Consented VS Proposed

DESIGN SUMMARY

Stephenson's Way

Planning Permission Nr.: 2018/2316/P

Consented vs Proposed - Fourth Floor

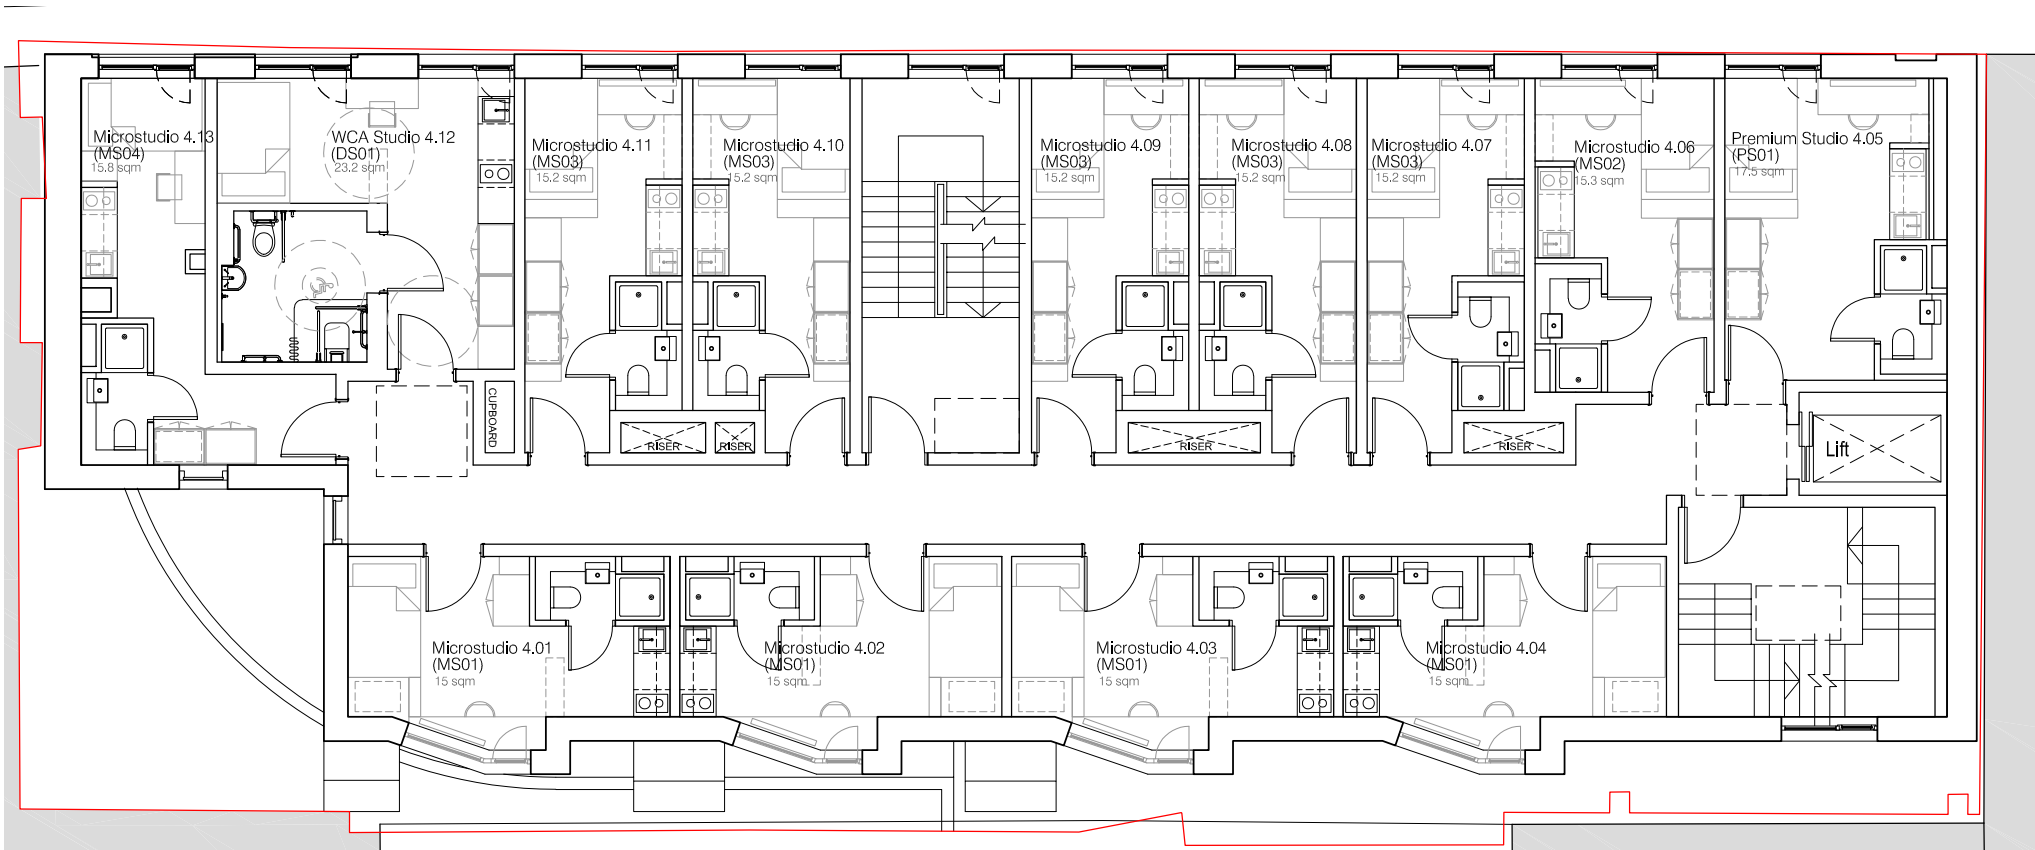
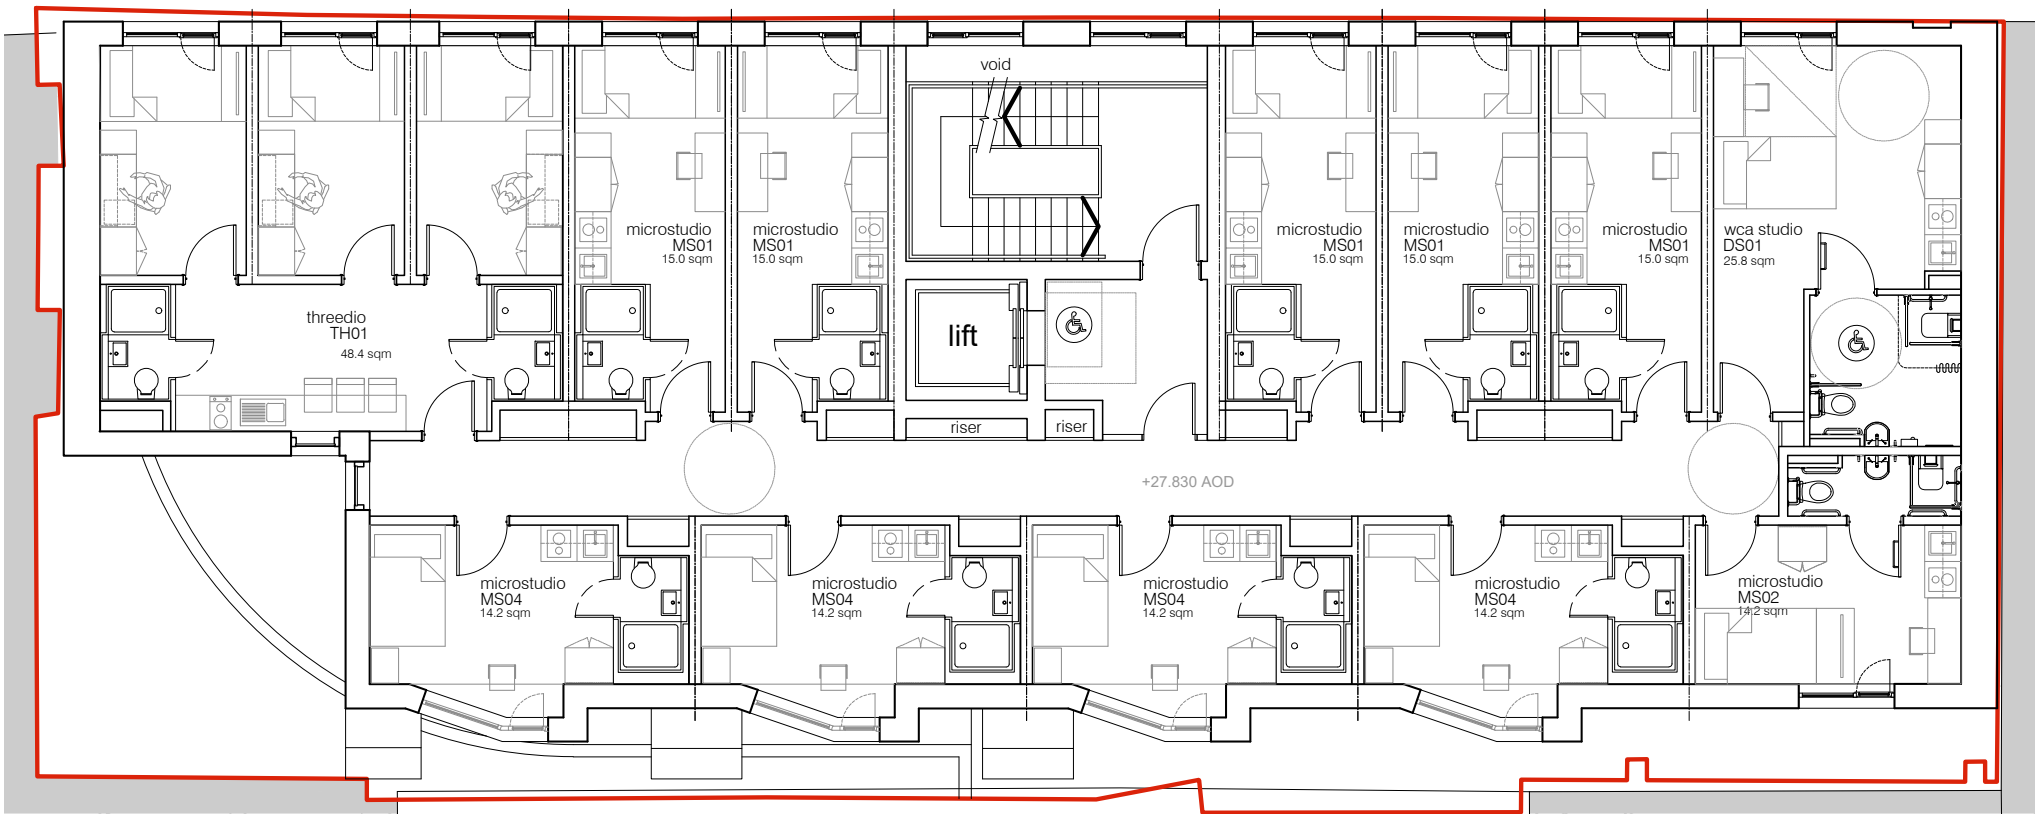
- 1. Secondary stair core added to comply with building safety act and revised building regulations.
- 2. Increased plant areas and UKPN substation added to comply with revised building regulations and increased services requirements.
- 3. Reduction in numbers of studios from 78 to 72 rooms due to secondary stair core and removal of threedio's on the recommendations of the fire consultant as a result of revised building regulations, but still maintaining minimum room sizes required.
- 4. Relocation of platform lift to rear façade to allow for access to the bin store due to new stair location.
- 5. Minor correction to existing ground floor levels due to inaccurate original survey.
- 6. Minor amendments to floor levels due to detailed structural design.

Consented vs Proposed - Fifth Floor

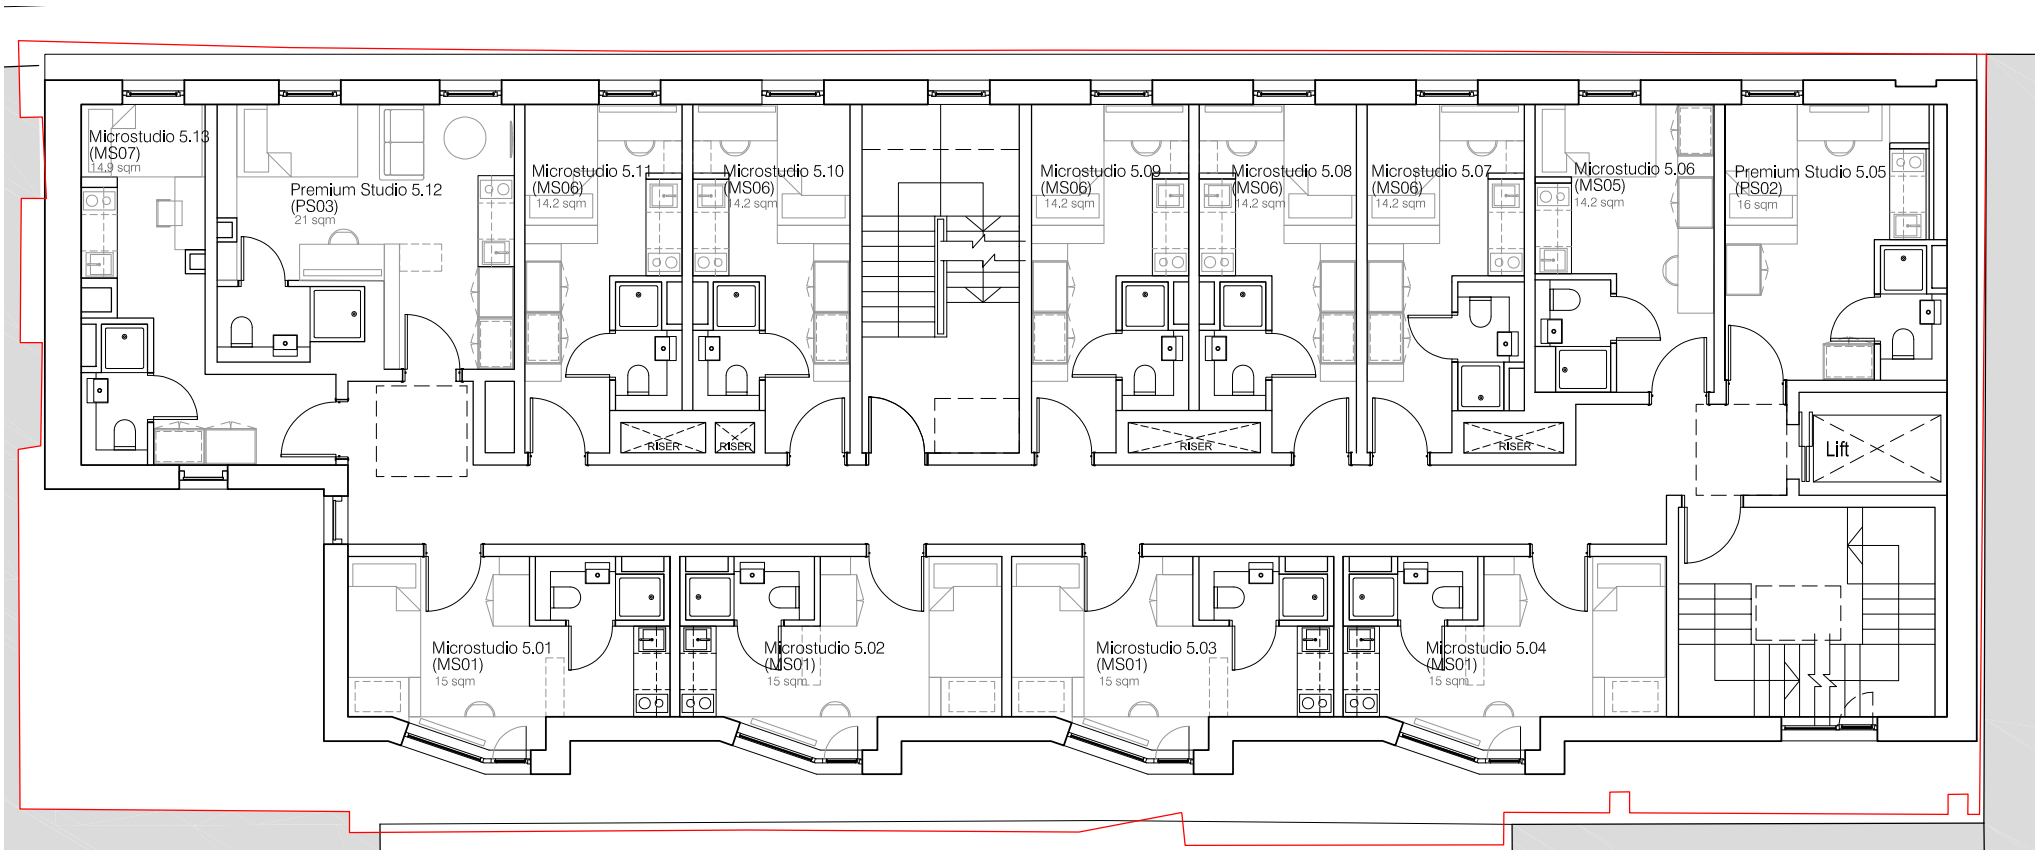
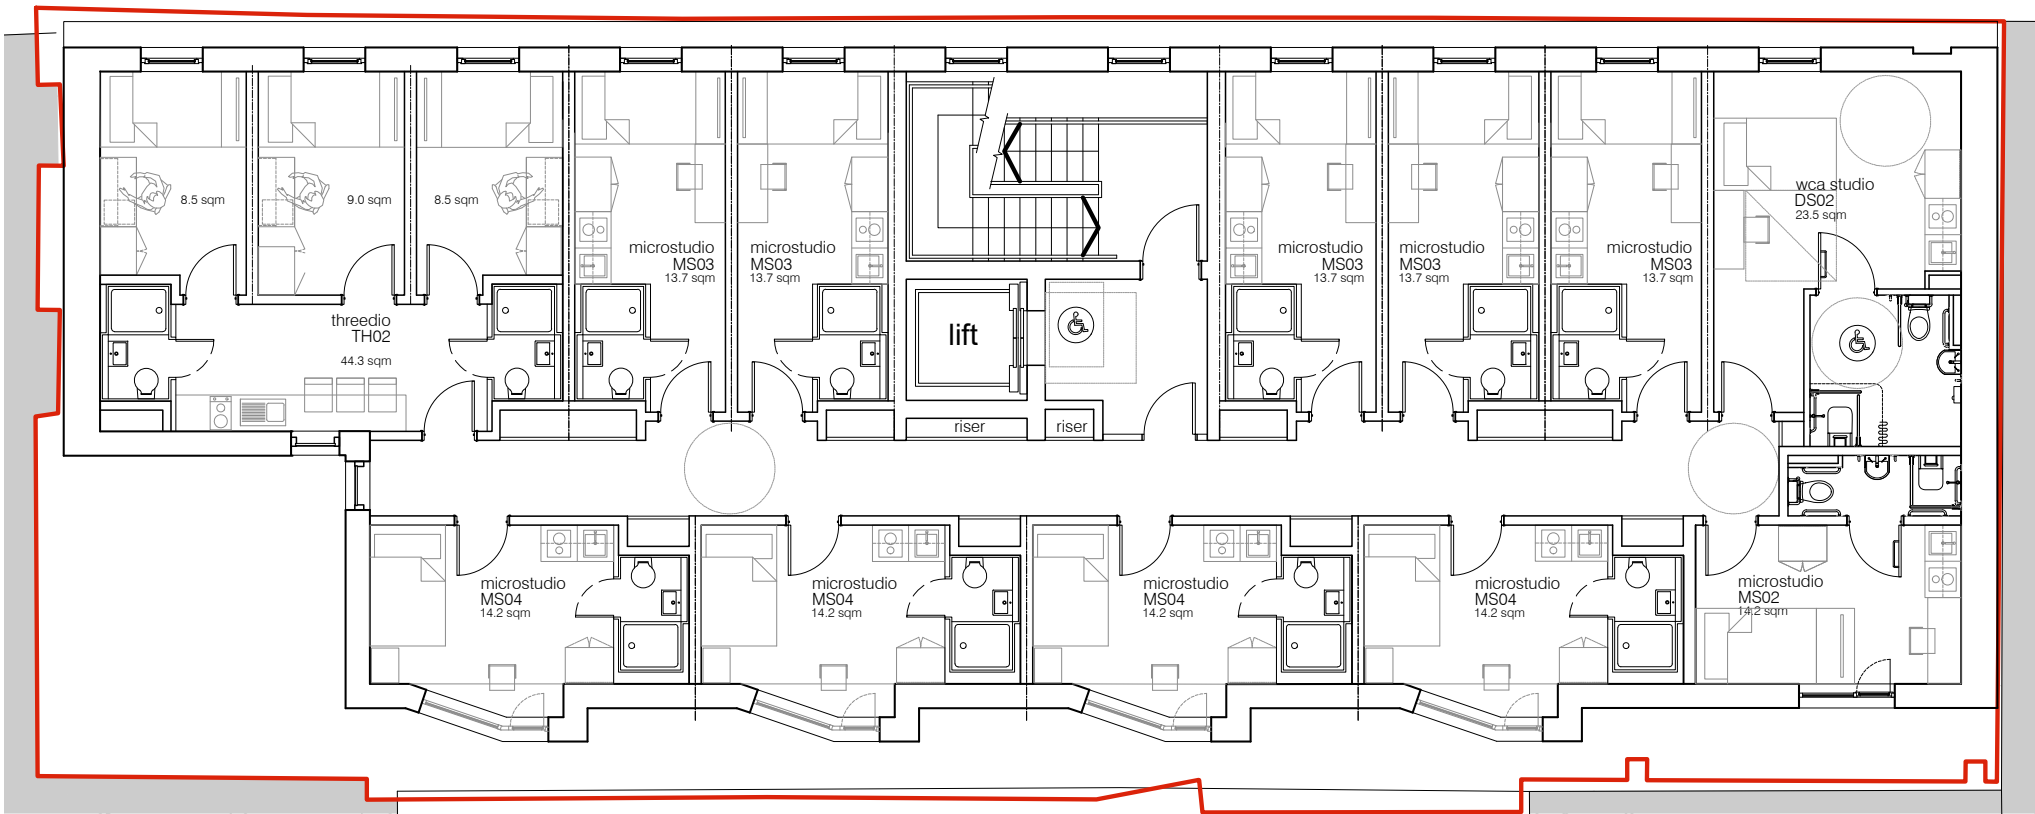
- 1. Secondary stair core added to comply with building safety act and revised building regulations.
- 2. Increased plant areas and UKPN substation added to comply with revised building regulations and increased services requirements.
- 3. Reduction in numbers of studios from 78 to 72 rooms due to secondary stair core and removal of threedio's on the recommendations of the fire consultant as a result of revised building regulations, but still maintaining minimum room sizes required.
- 4. Relocation of platform lift to rear façade to allow for access to the bin store due to new stair location.
- 5. Minor correction to existing ground floor levels due to inaccurate original survey.
- 6. Minor amendments to floor levels due to detailed structural design.

Consented vs Proposed - Sixth Floor

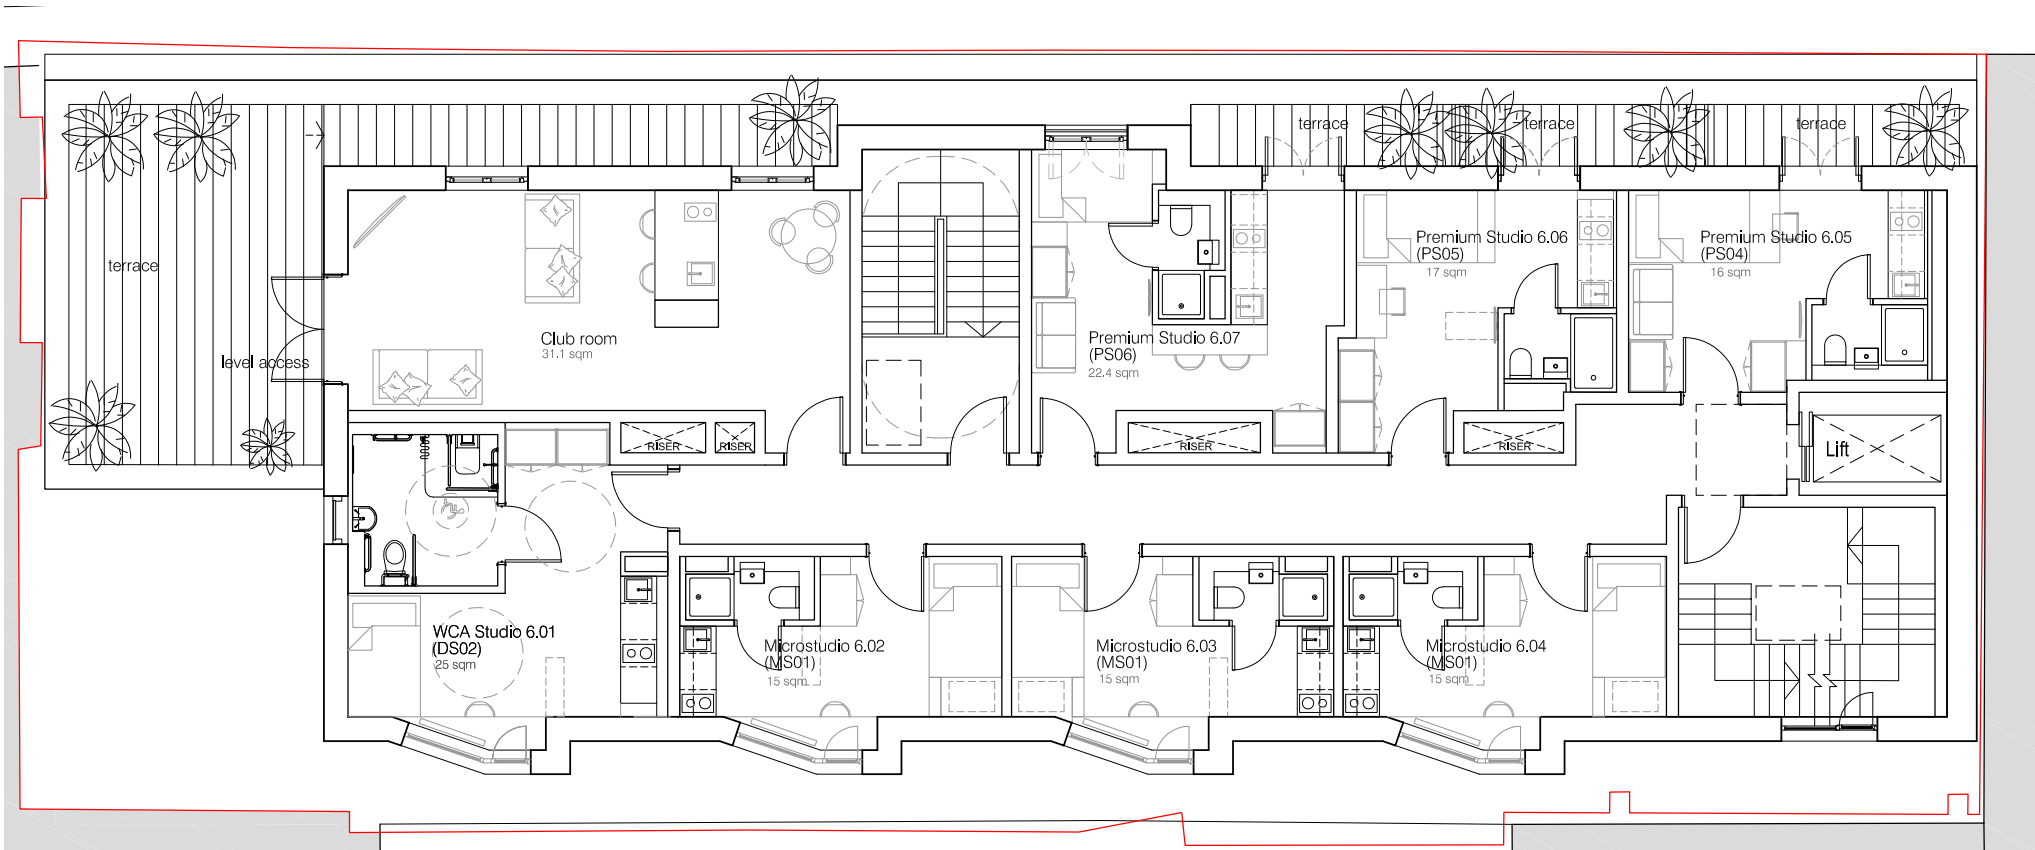
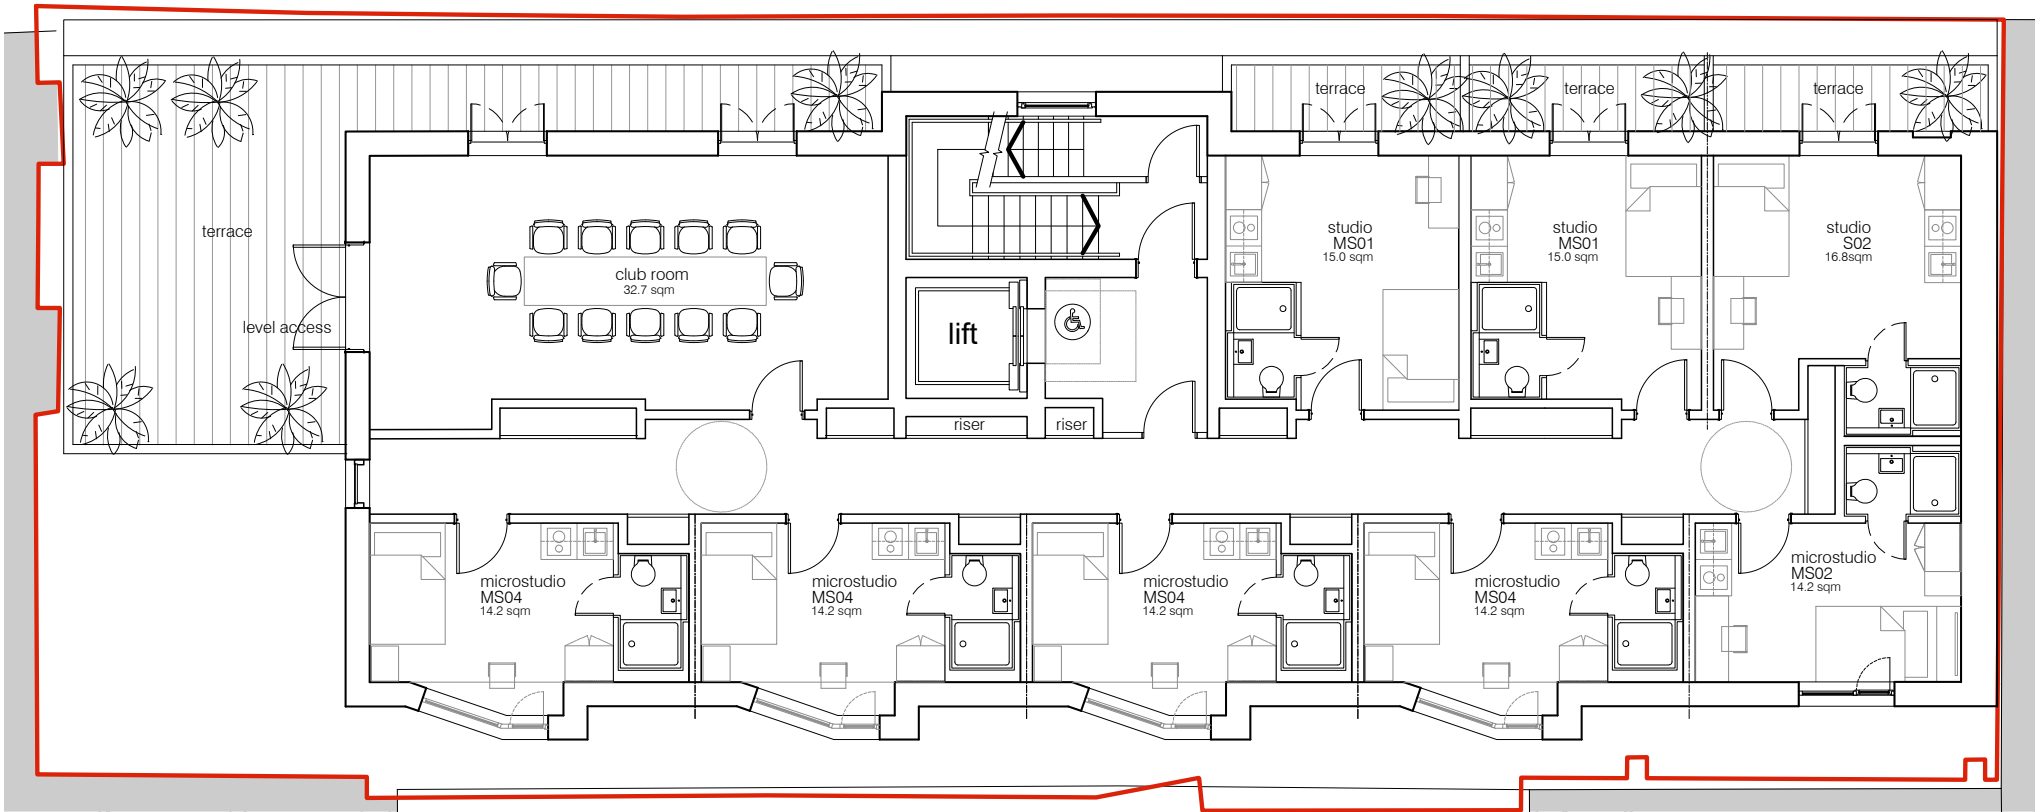
- 1. Secondary stair core added to comply with building safety act and revised building regulations.
- 2. Increased plant areas and UKPN substation added to comply with revised building regulations and increased services requirements.
- 3. Reduction in numbers of studios from 78 to 72 rooms due to secondary stair core and removal of threedio's on the recommendations of the fire consultant as a result of revised building regulations, but still maintaining minimum room sizes required.
- 4. Relocation of platform lift to rear façade to allow for access to the bin store due to new stair location.
- 5. Minor correction to existing ground floor levels due to inaccurate original survey.
- 6. Minor amendments to floor levels due to detailed structural design.
